Conservation Commission Meeting

Subject: Request to Extend Existing Order of Conditions
Order of Conditions (DEP File No, 321-0169)
551 Rear Arsenal Street, Arsenal Park Phase A Improvements

Re: 57 Coolidge Ave – DEP 321-0175 WWO-2021-02 (the "Project")
Bio-retention detail revision

Regarding: 10-30 Manley Way
DEP file No. 321-0188
Response to Conservation Commission Comments

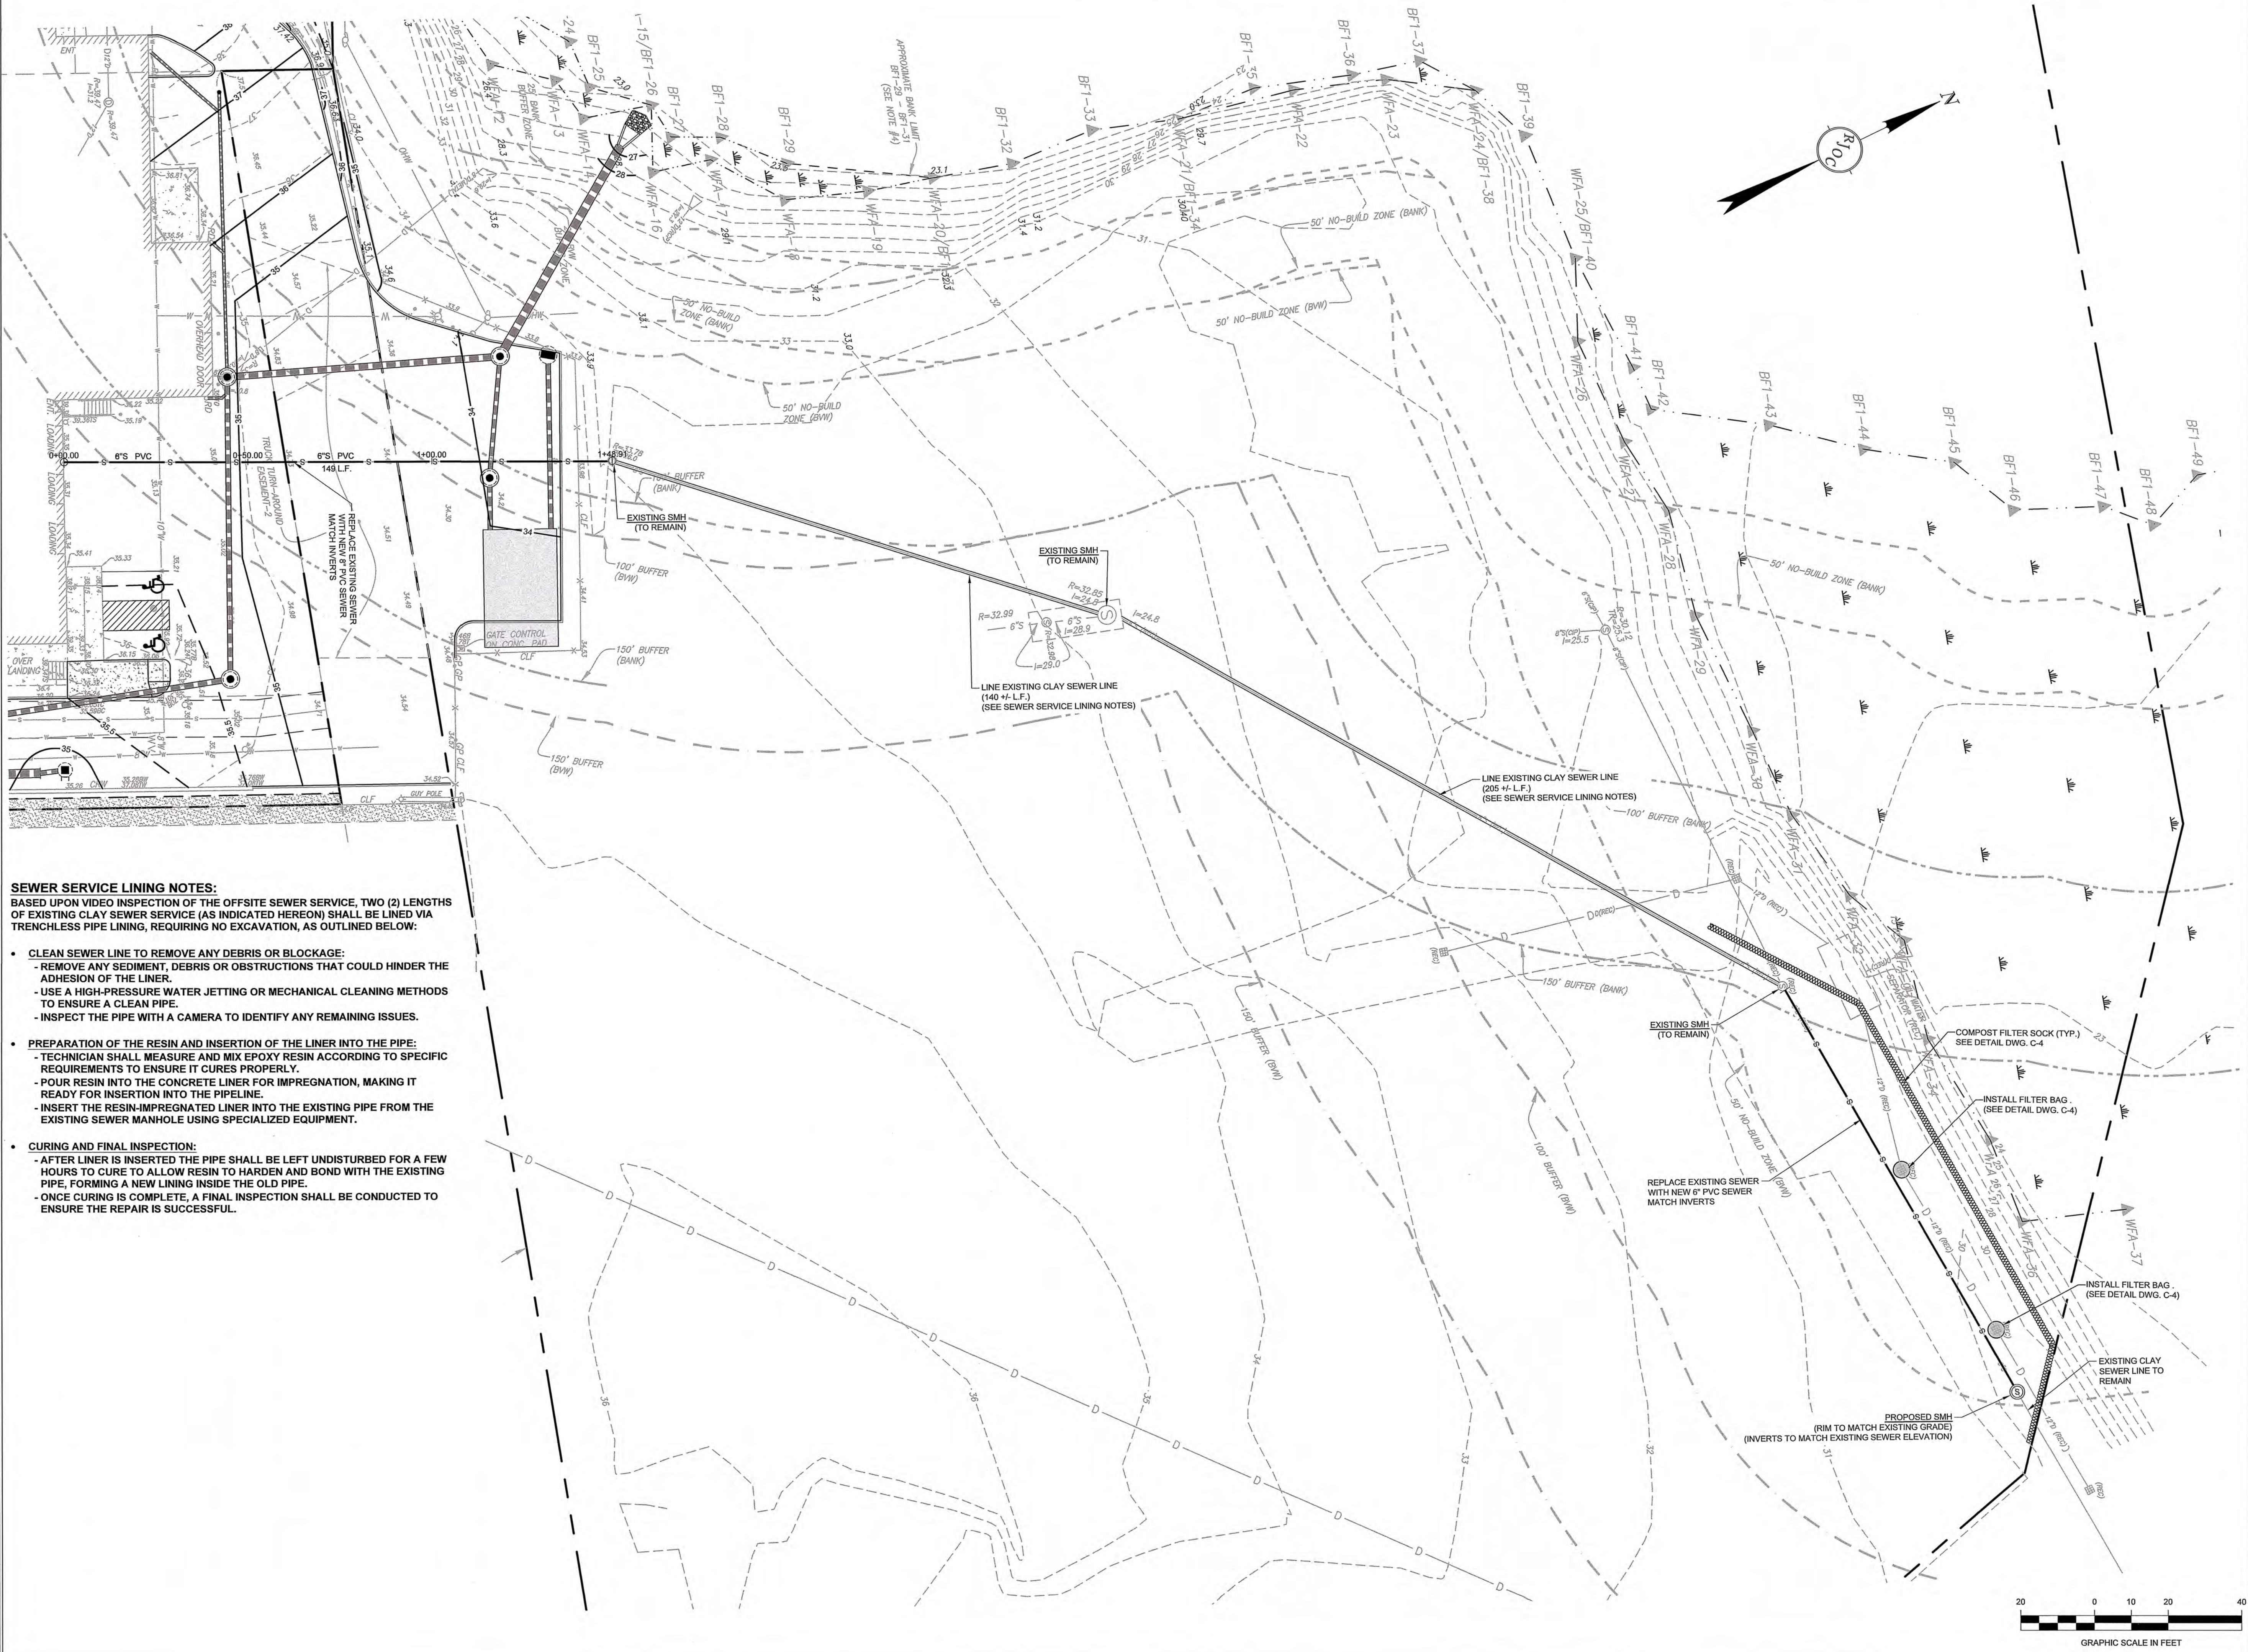
4. *Initial comment: Confirm the condition of the existing sanitary sewer pipe in the 100-foot buffer zone on the city property north of the site in case it needs to be repaired or replaced now as part of this project.*

- **A video camera survey of the pipe was performed by John's Sewer & Drain on August 5, 2024. The survey revealed that some repairs are necessary within the existing sewer line located on the city-owned parcel. RJOC has prepared an Offsite Sewer Repair Plan (Sheet C-2D) as part of this resubmittal indicating that two portions of the existing sewer line shall be**

repaired via trenchless pipelining and another portion shall be removed and replaced. Erosion control measures have been proposed around the pipe removal and replacement location as shown on Sheet C-2D.
